Subject: Issuance of Amendment No. 6 to Facility Operating License
NPF-21, WPPSS Nuclear Project No. 2

AMENDMENT TO FACILITY OPERATING LICENSE

License No. NPF-21
Amendment No. 6

SAFETY EVALUATION

FIGURE 6.2.1-1
OFFSITE ORGANIZATION

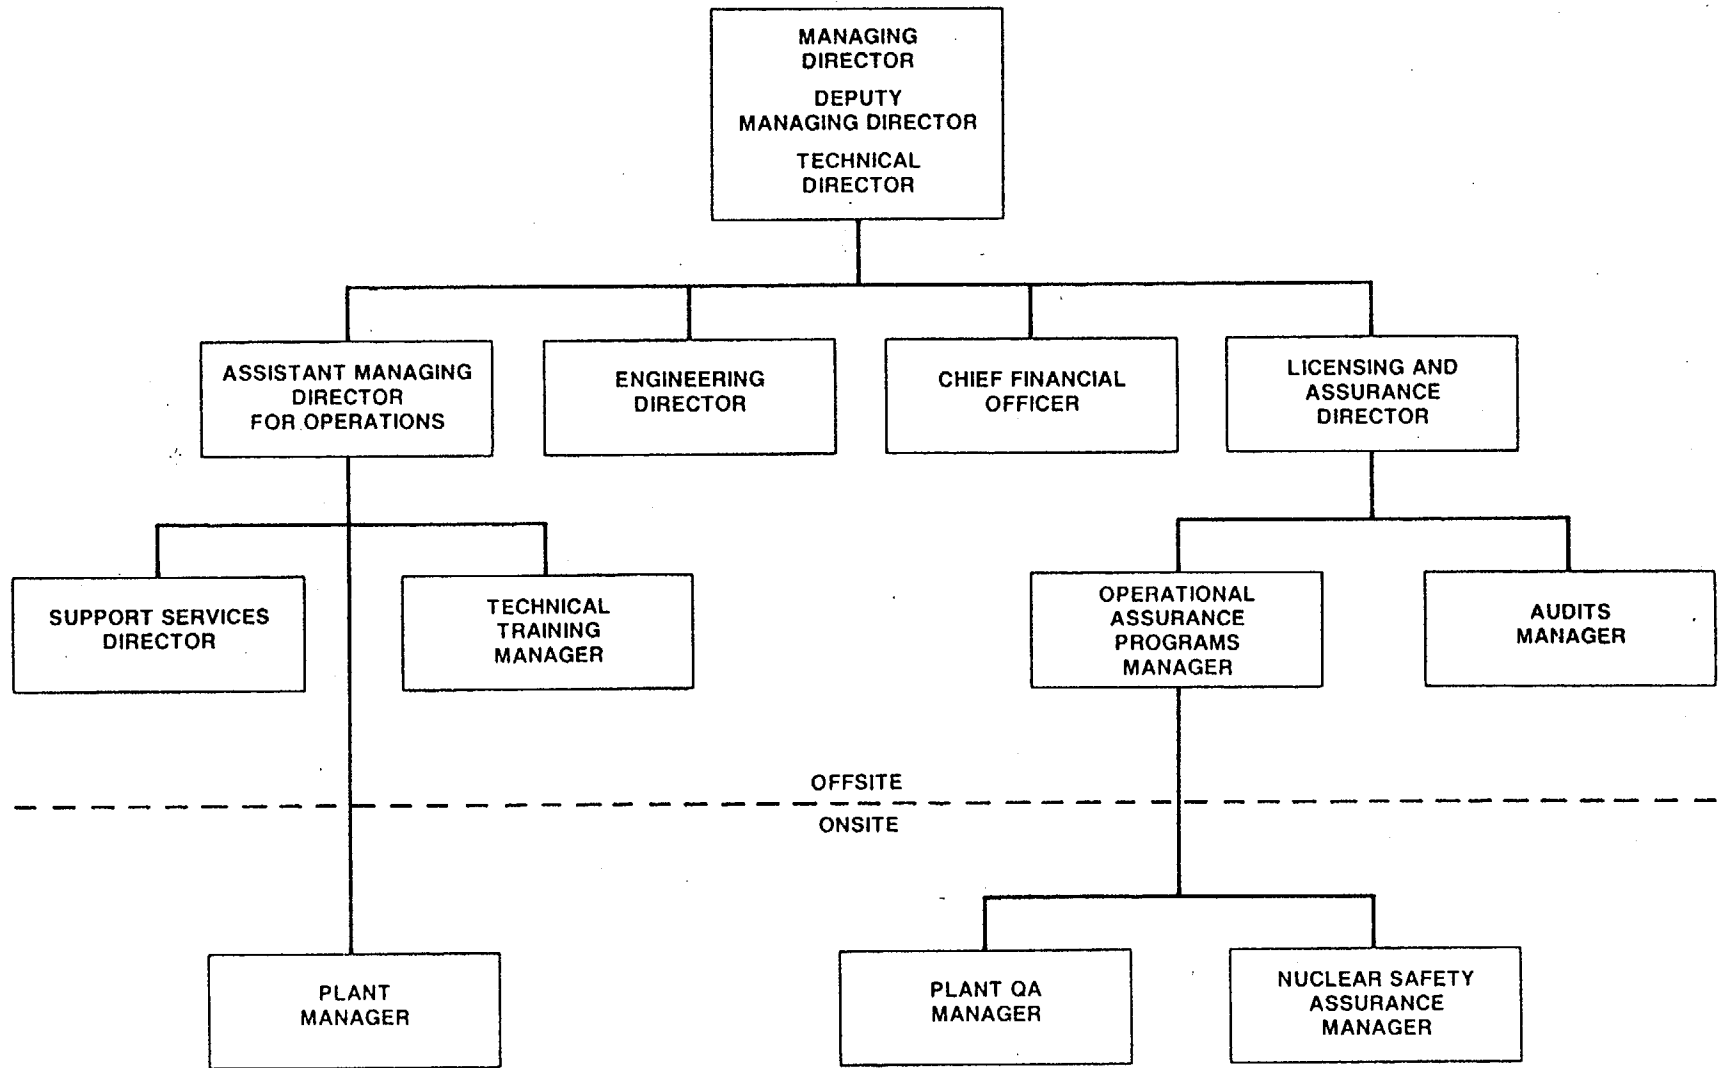
- (6) Technical Specification 6.0, Administrative Controls: In Figure 6.2.1-1, change "Power Generations Director to Assistant Managing Director for Operations, Technology Director to Engineering Director and move Support Services Director Functions under Assistant Managing Director for Operations." In Figure 6.2.2-1a, change "Technical Training Manager to

In Item 6 above, the licensee proposed several corporate and plant staff changes. In the corporate area, the title of Power Generations Director has been changed to Assistant Managing Director for Operation. The title of Technology Director has been changed to Engineering Director. The organizational unit under the Support Services Director, which reported to the Office of the Managing Director, now reports to the Assistant Managing Director for Operations. There has been no deletion of support for WNP-2 or change of personnel. The staff finds these changes acceptable as they meet the acceptance criteria of Standard Review Plan Section 13.1.1 (NUREG-0800).

FIGURE 6.2.2-1a
UNIT ORGANIZATION

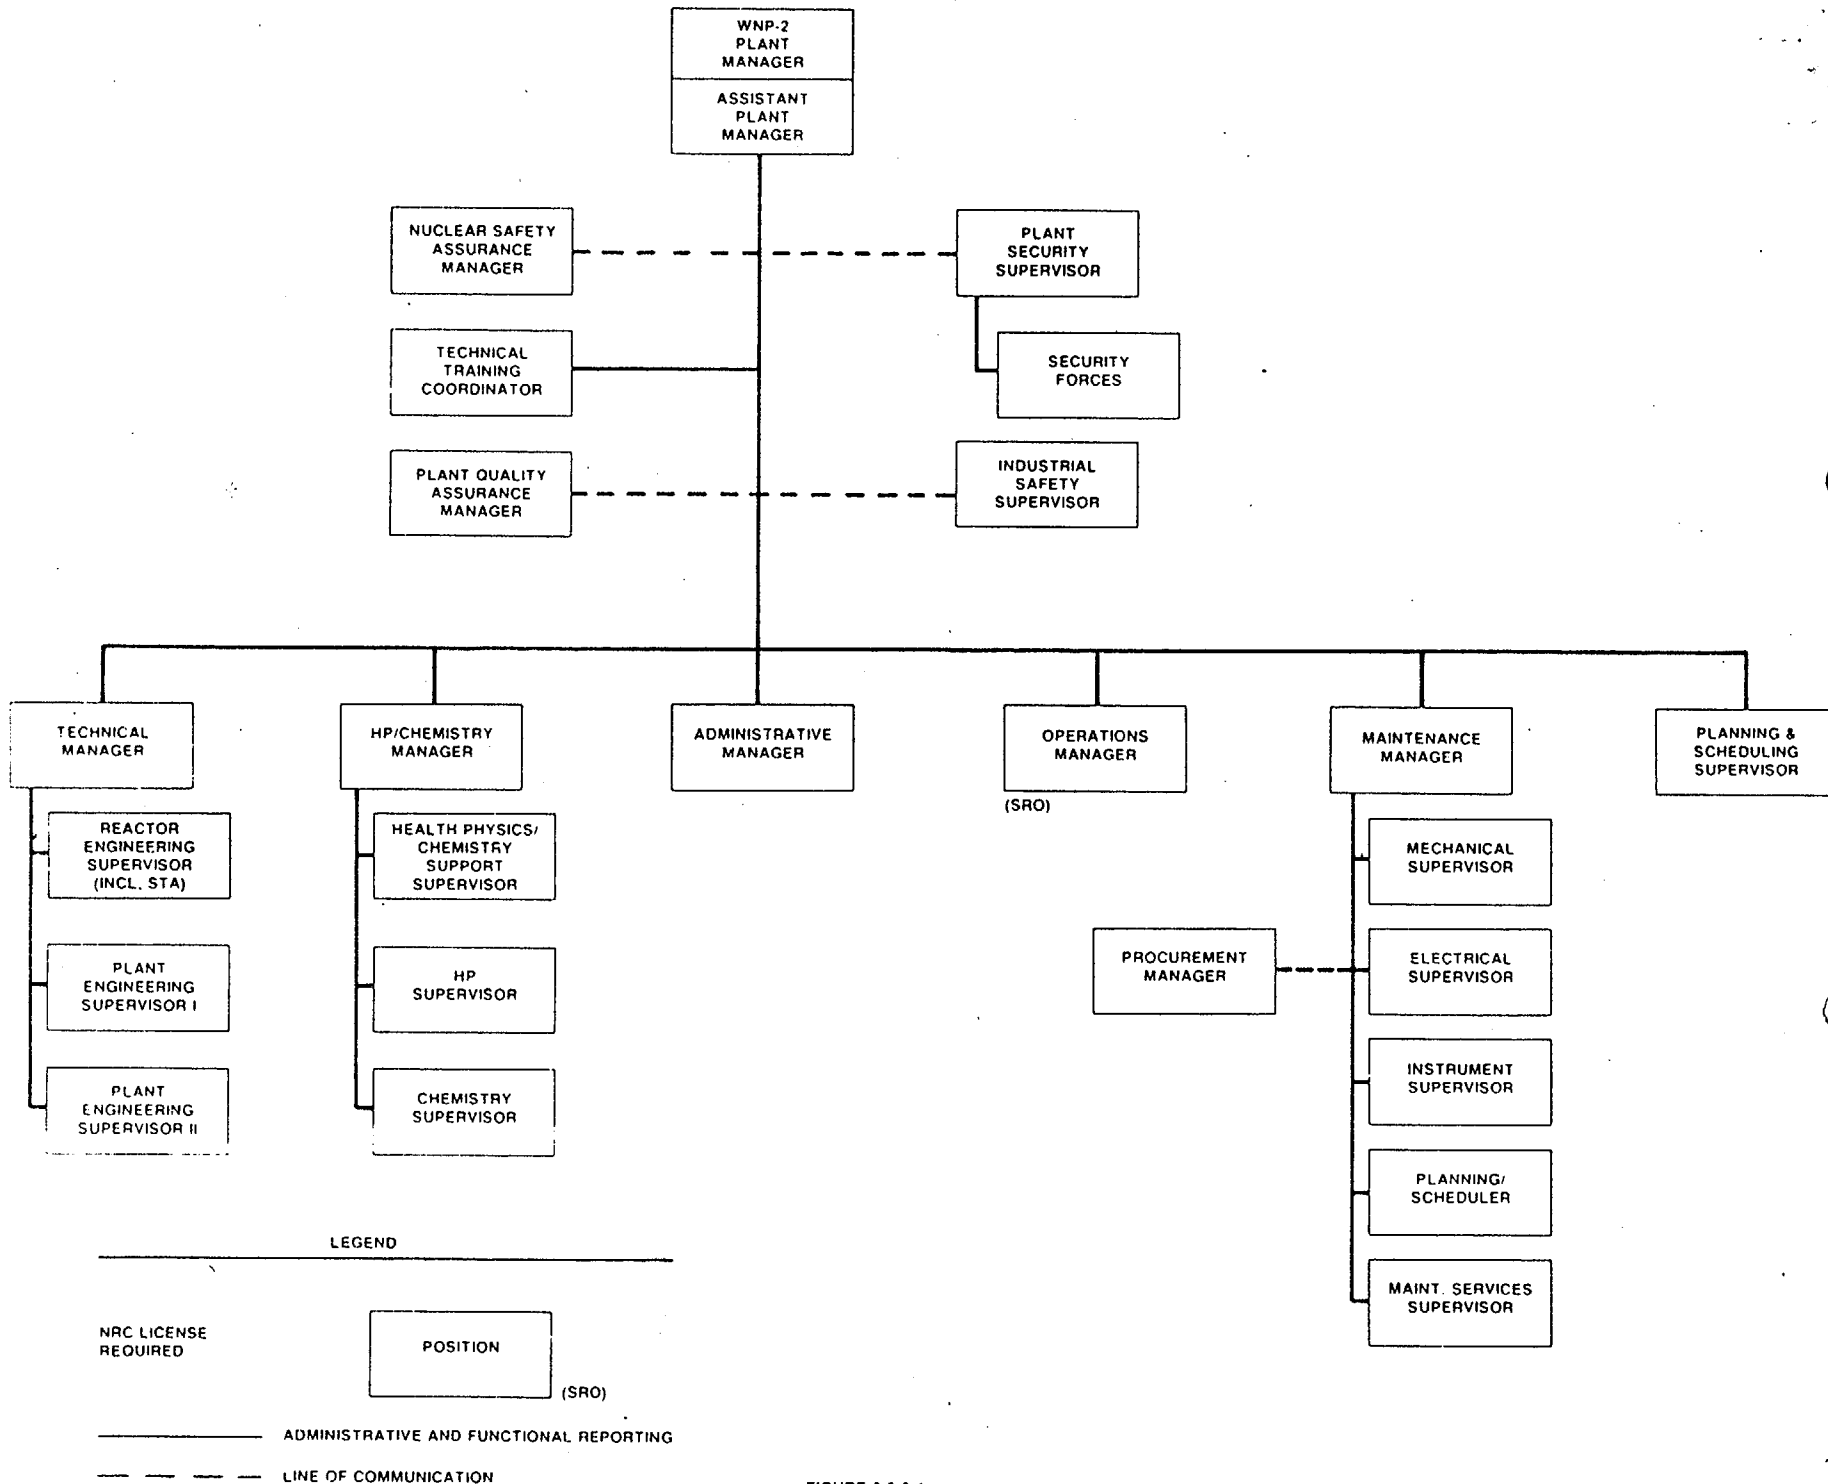
Technical Training Coordinator." Under Assistant Plant Manager, add Planning and Scheduling Supervisor, and under Technical Manager, add Plant Engineering Supervisor I & II. Also, change Health Physicist to Health Physics/Chemistry Support Supervisor, and under Maintenance Manager, delete, Spare Parts Material Supervisor and add Procurement Manager.

The title of Health Physicist has been changed to Health Physics/Chemistry Support Supervisor and the title Technical Training Manager has been changed to Technical Training Coordinator. The position of Planning and Scheduling Supervisor who reports to the Plant Manager has been added. The position of Spare Parts Material Supervisor has been deleted with the functions now included in the new position of Procurement Manager. The Shift Technical Advisors are now shown as part of the Reactor Engineering Staff under the Technical Manager, and two Plant Engineering Supervisors have been added to the staff of the Technical Manager. In addition, there were several minor administrative changes. There has been no deletion of support to WNP-2. The staff finds these changes acceptable as they meet the acceptance criteria of Standard Review Plans Section 13.1.2 (NUREG-0800).
